# Corporate Center Pasadena

Survey and Report by Sharon Toji  
Voting Delegate, ANSI A117.1 Committee and  
Accessible Signage Consultant  
With Oversight by Timothy McCormick, P.E. & CASp

## Final Narrative Report on Exterior Accessible Path of Travel

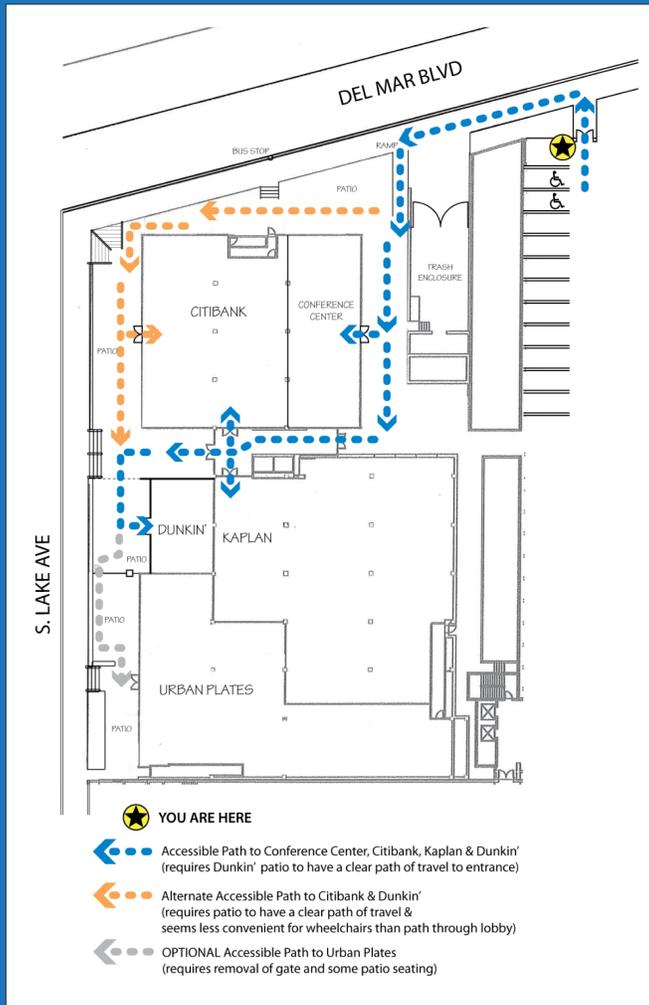
**The photo on the left shows the pillar where the site plan can be mounted. The other photos are of the less convenient path of travel around the building. Move planters to create 48" path.**

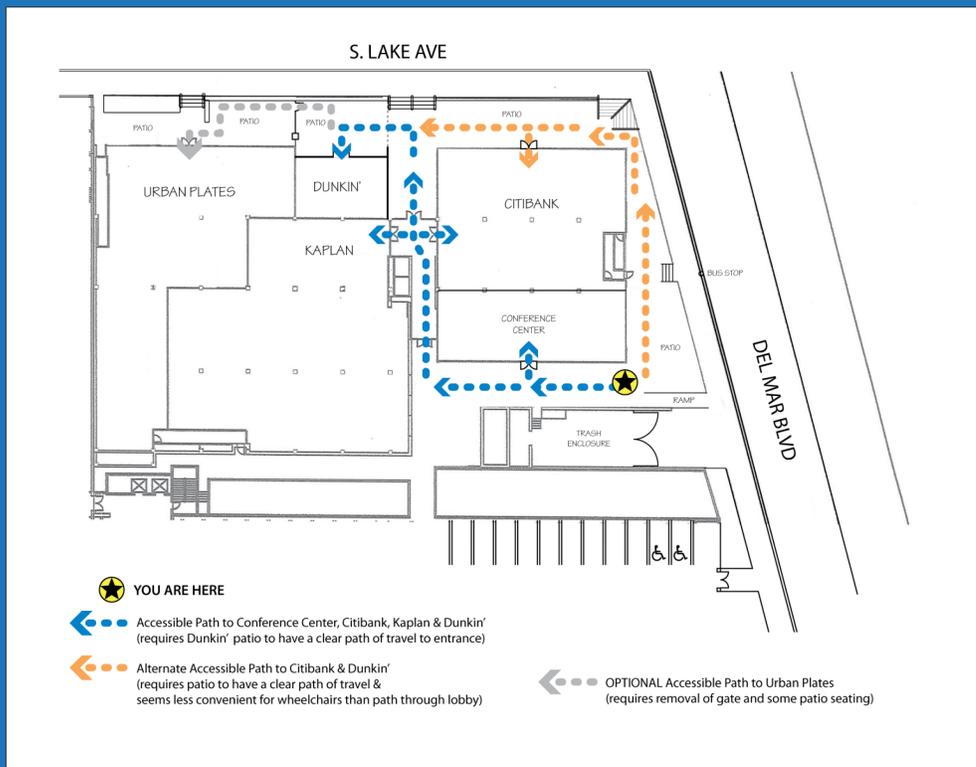
(Sign 1) The two accessible spaces are just a few feet from the pedestrian entrance. Exit the building through double doors and turn left to walk to the ramp. We recommend a site plan with a clearly marked accessible path of travel be mounted on the wall at the side of the double exit doors. Simplify the plans with as few extra details as possible.

**Site Plan 1:** This is a rough idea of what such a plan might look like, with three paths of travel marked, depending on what is resolved with the access to Urban Plates, and whether Management will move some planters and furniture. The Conference Facility can be included, or if there is no independent access, it can be omitted. The text on the plan should make it clear that the paths shown are the accessible paths of travel to the various destinations. If no changes are made to the Urban Plates patio area, remove the pale gray\* extension of the path of travel. If the planters are not moved, remove the orange path.

## **Layout for Site Plan 2 (for mounting on column at top of ramp).**

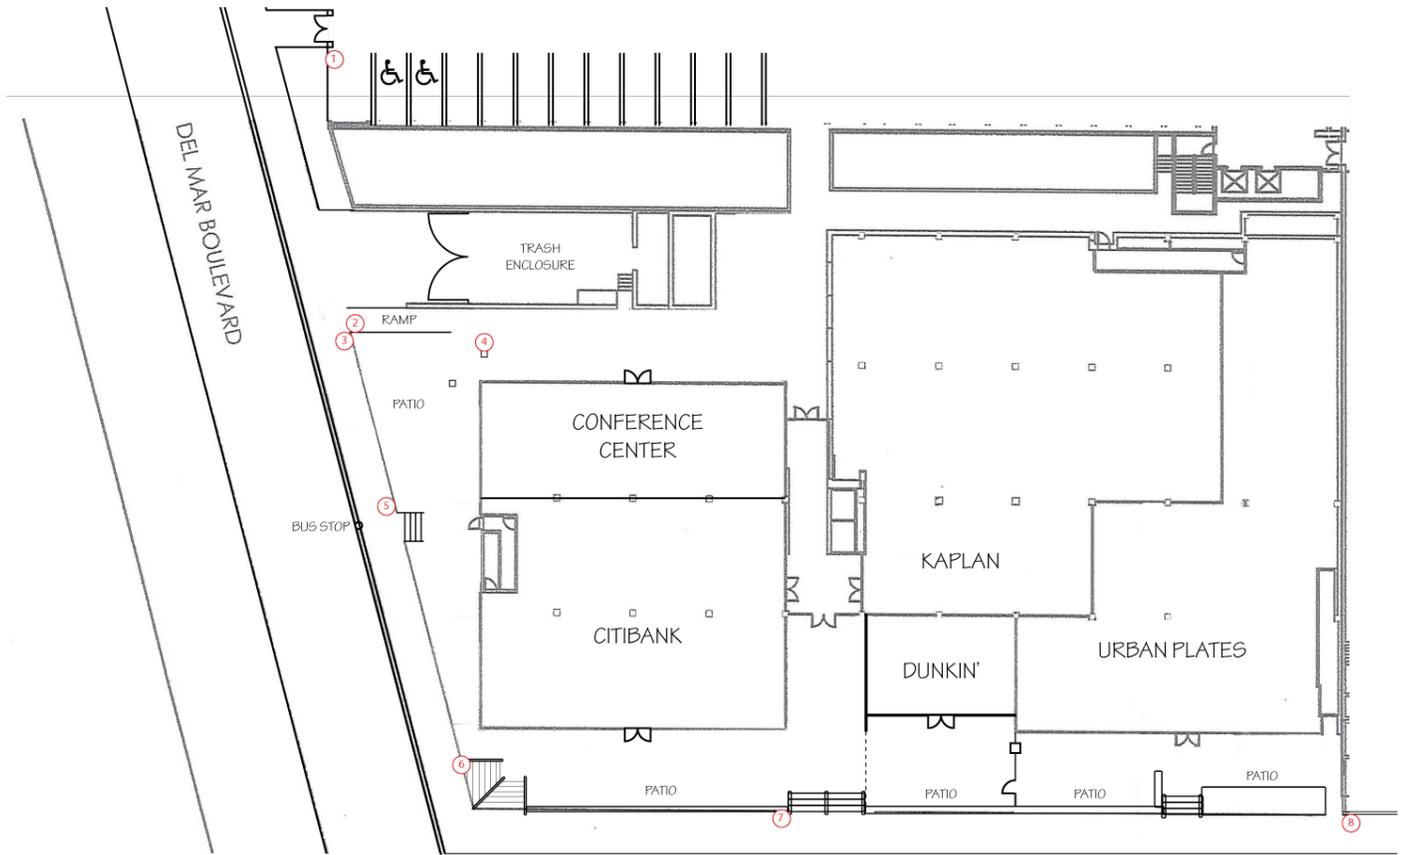
(Sign 4) This site plan is provided for those coming up the ramp from the bus stop, or along South Lake Ave. They did not have access to the plan mounted in the parking garage. Include the gray path\* only if a clear path is provided through Urban Plates. The orange path is included if the planters are not obstructing the clear width.

\*Note on color of paths of travel: If the path shown by the gray extension is created by removing patio seating and the gate, the color should match the remainder of that path of travel.
